TO: DEVELOPMENT REVIEW BOARD **DATE:** August 21, 2003
FROM: CURRENT PLANNING SERVICES
SUBJECT: CASE 181-DR-1987#3
REQUEST: Approve site plan & elevations for an expansion to the existing facility, to include additional service bays and office space.
PROJECT NAME: Infiniti Of Scottsdale
LOCATION: 6910 E McDowell Rd

REQUEST: The applicant seeks approval of site plan and elevations relating to an expansion of the existing dealership building.

Stipulations for Case: Infiniti of Scottsdale 181-DR-1987 #3

SITE PLAN

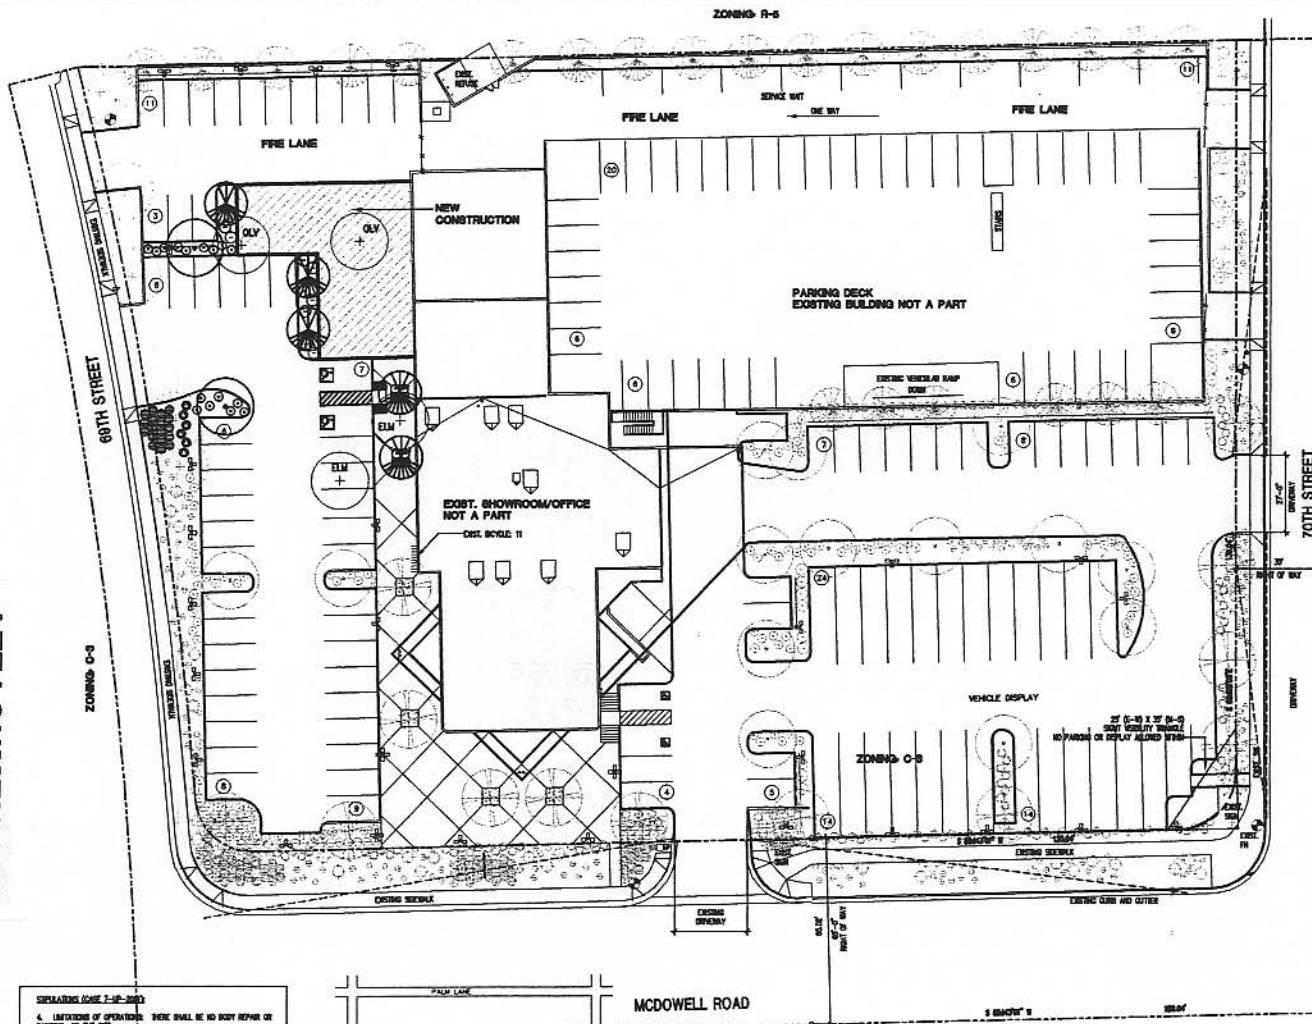
10. Revise the site plan to show the correct zoning on the north side of the property as R1-7.

- A. Revise site plan to provide additional accessible parking spaces to comply with the Zoning Ordinance requirements of Article IX.
- B. Provide additional bicycle parking spaces to comply with the Zoning Ordinance requirements of Article IX.
